INCH - POUND
MIL-C-28840A
AMENDMENT 6
5 May 2000
SUPERSEDING
AMENDMENT 5
5 August 1993

MILITARY SPECIFICATION

CONNECTORS, ELECTRICAL, CIRCULAR THREADED, HIGH DENSITY, HIGH SHOCK SHIPBOARD, CLASS D, GENERAL SPECIFICATION FOR

This amendment forms a part of MIL-C-28840A, dated 26 May 1981, and is approved for use by the Space and Naval Warfare Systems Command, Department of The Navy, and is available for use by all Departments and Agencies of the Department of Defense.

FIGURE 5. Connector, receptacle, electrical, interface dimensions.”

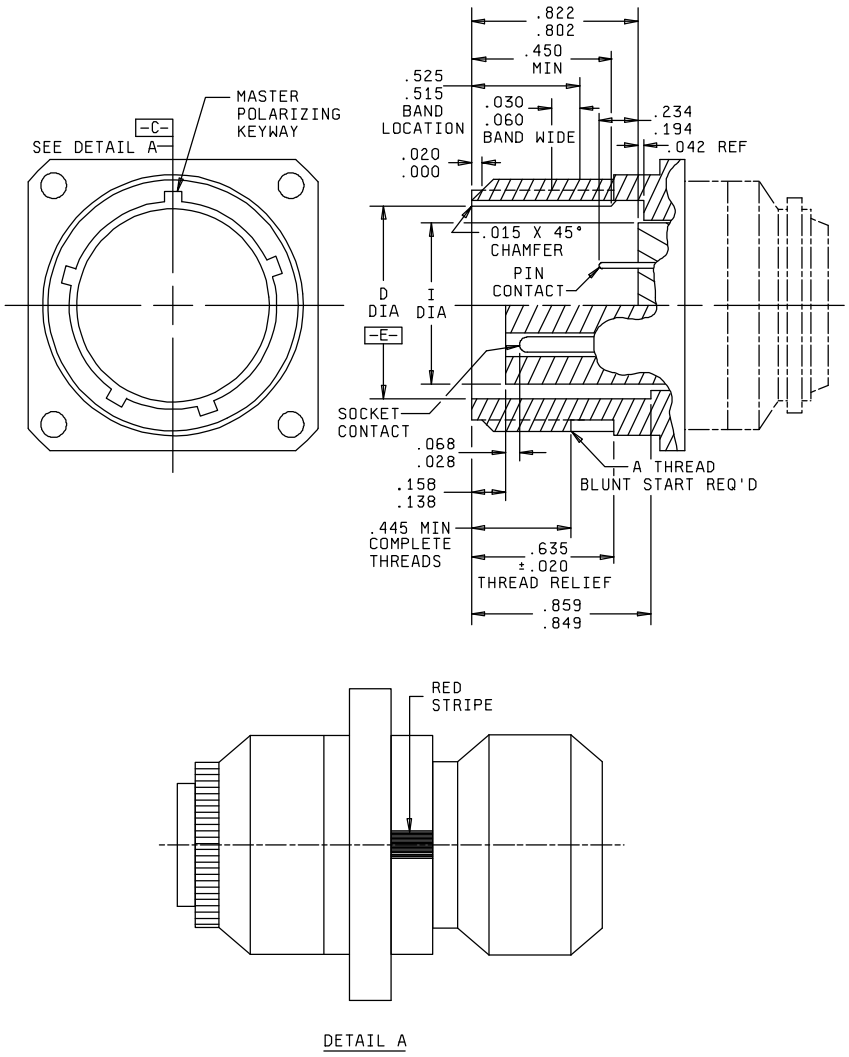
FIGURE 5, delete and substitute:

FIGURE 10. External bending moment test set -up.”

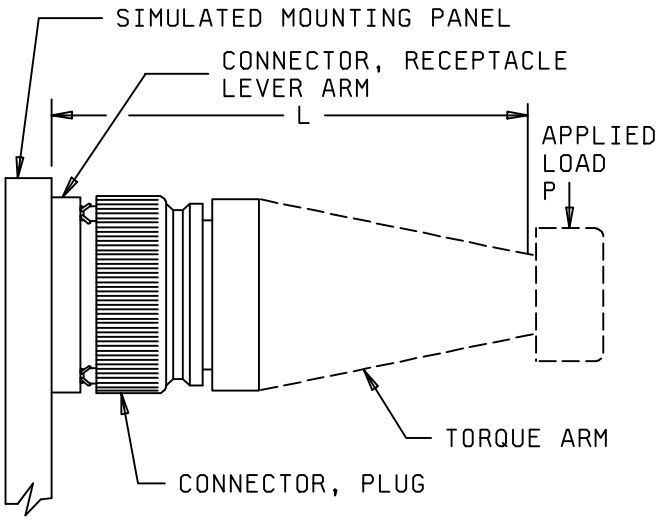
FIGURE 10, delete and substitute:
“

"4.6.17 External bending moment (see 3.21). The receptacle connector shall be mounted as in normal service to a rigid panel. Before mating the plug connector to the receptacle, and adapter or test torque arm shall be attached as shown on figure 10. After mating the plug and receptacle connectors, the distance "L" from the point of load application "P" to the mounting panel shall be determined. The load shall be applied at point "P" and shall then be determined as the bending moment listed in table XII, divided by the level arm "L". This load shall be applied at a rate of approximately 10 pounds per second until the required load is achieved. The applied load shall be held for 1 minute, then the load shall be released.

FIGURE 14. Test gauge, pin, gauge location, and retention.”

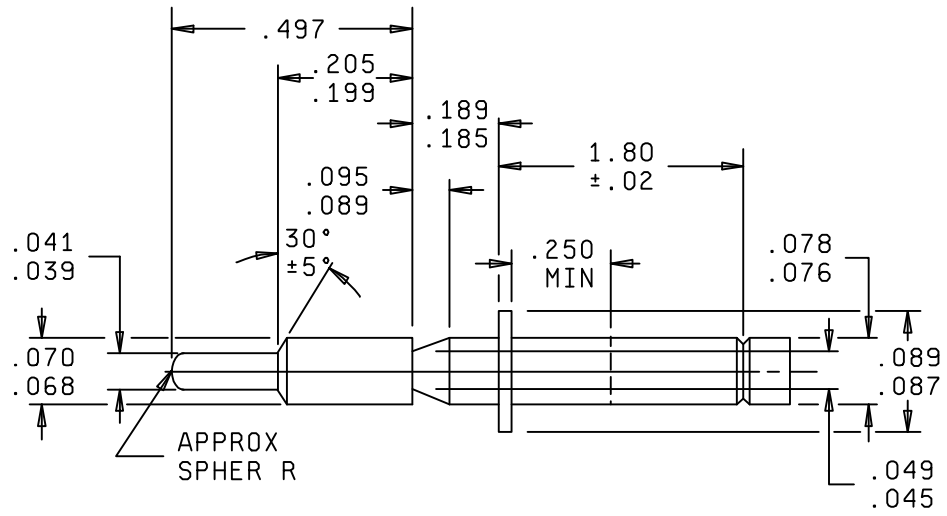
FIGURE 14: Delete and substitute new figure 14.

NOTES:
1. Material: Hardened tool steel.
2. Finish: 32 microinches polished.
3. Design of rear extension is optional, but must have a groove provided as indicated.
4. Dimensions are in inches.
5. Metric equivalents are given for information only.
6. All diameters concentric to each other within a .004 TIR.
